11 August 2006

Docket No.: 71-9027
TAC Nos. L23922, L23895 and L23896

Subject: Additional Supportive Information for the Model 741-OP Type B Container

TITLE		MODEL 741-OP	
SIZE	DWG. NO.	R741-OP	REV
A	SCALE: NONE	SHEET: 1 OF 7	D

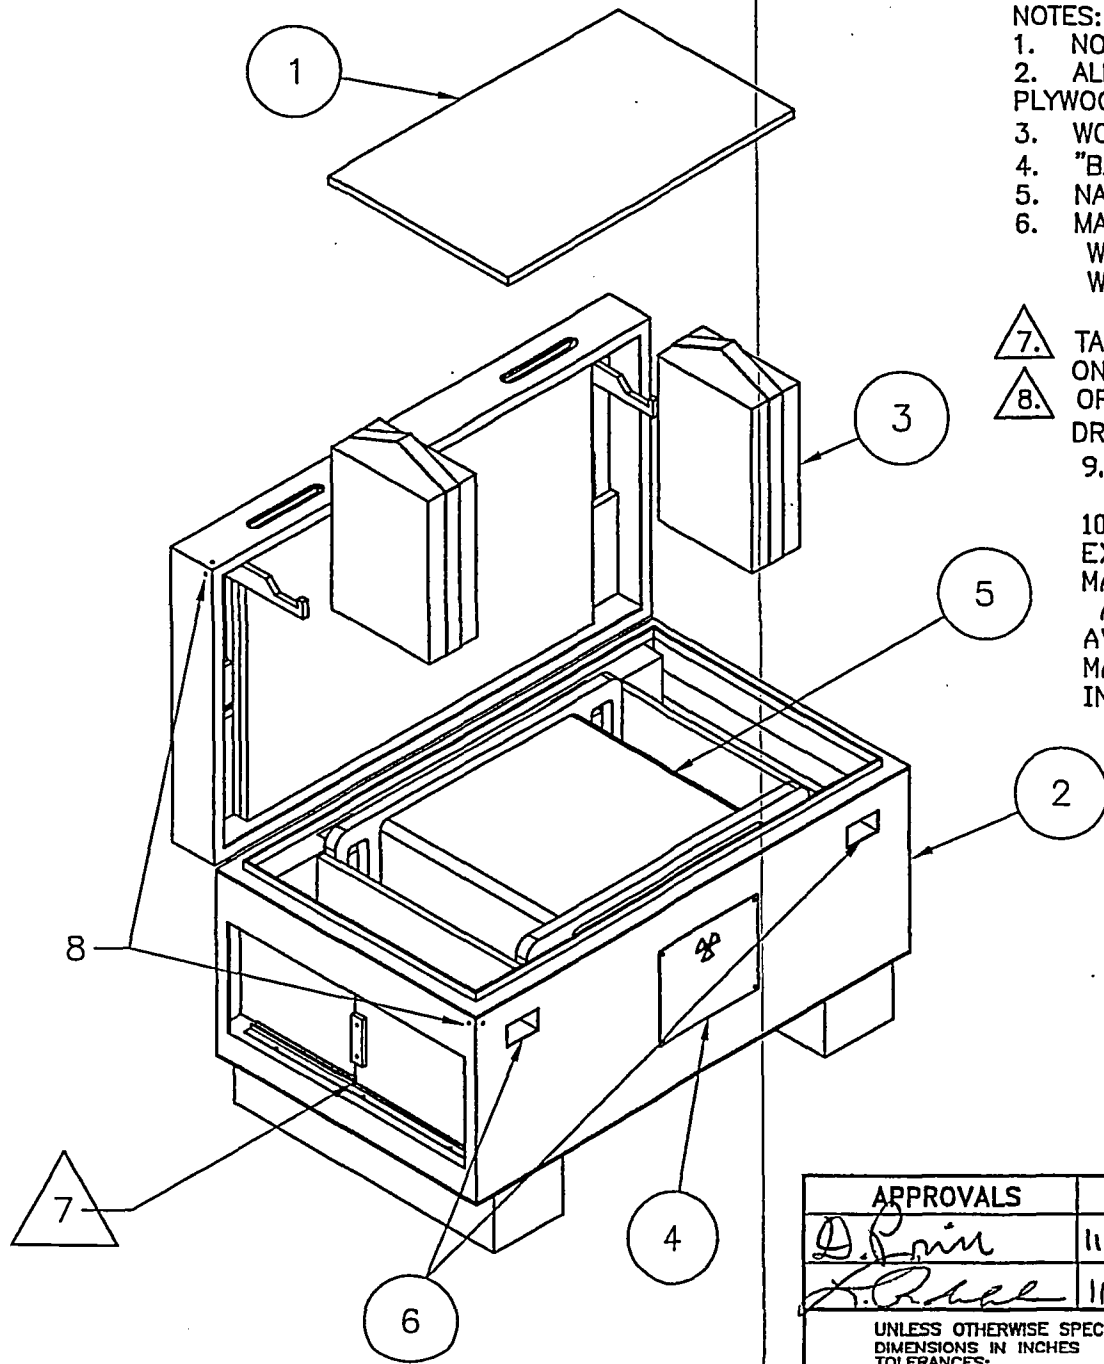
- Drawing R741-OP Revision D is enclosed to correct the device referenced in Item 5 on sheet 1 of that drawing.
- Section 8.1.5 is modified to incorporate the lock assembly component test as requested by your staff.

ITEM	QTY.	DESCRIPTION
6	2	PADLOCK
5	1	741 PROJECTOR PER R74190
4	1	NAME PLATE, STEEL, FIRE PROOF
3	2	WOOD BLOCK INSERTS (SHEET 3)
2	1	OVERPACK, 16 ga CRS FEET 13 ga CRS
1	1	WOOD SUPPORT BASE, 3/4 THICK
